Well Name: RED HILLS WEST 22/15 FED COM	Well Location: T26S / R32E / SEC 22 / SESW /	County or Parish/State:
Well Number: 512H	Type of Well: OIL WELL	Allottee or Tribe Name:
Lease Number: NMNM027507	Unit or CA Name:	Unit or CA Number:
US Well Number: 3002550972	Well Status: Approved Application for Permit to Drill	Operator: MEWBOURNE OIL COMPANY

Sundry ID: 2717741

Type of Action: APD Change

Procedure Description: Mewbourne Oil Company requests to make the following changes to the APD: 1.) Change well name from Red Hills West 22 B2MD Fed Com #2H to Red Hills West 22/15 Fed Com #512H. Please see attached updated C102 2.) Change BHL from 100' FNL & 1320' FWL (Sec 22, T26S, R32E) to 100' FNL & 1320' FWL (Sec 15, T26S, R32E) - New BHL lease #NMNM 118722. Please see attached updated C102 3.) Change Csg/Mud/Cement plan. Please see attached Dir Plot, Dir Plan & Sundry Drlg Program

WELL LOCATION AND ACREAGE DEDICATION PLAT

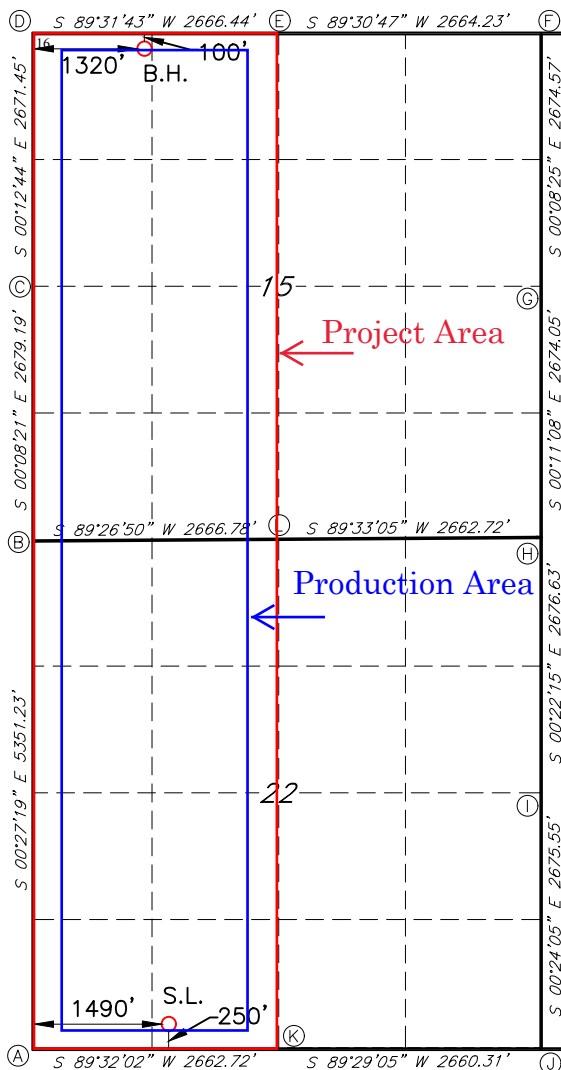
REV: NAME & BH CHANGE 02/17/23

UL or lot no.	Section	Township	Range	Lot Idn	Feet from the	North/South line	Feet From the	East/West line	County
N	22	26S	32E		250	SOUTH	1490	WEST	LEA

UL or lot no.	Section	Township	Range	Lot Idn	Feet from the	North/South line	Feet from the	East/West line	County
D	15	26S	32E		100	NORTH	1320	WEST	LEA
¹² Dedicated Acres 640	¹³ Joint or Infill	¹⁴ Consolidation Code	¹⁵ Order No.
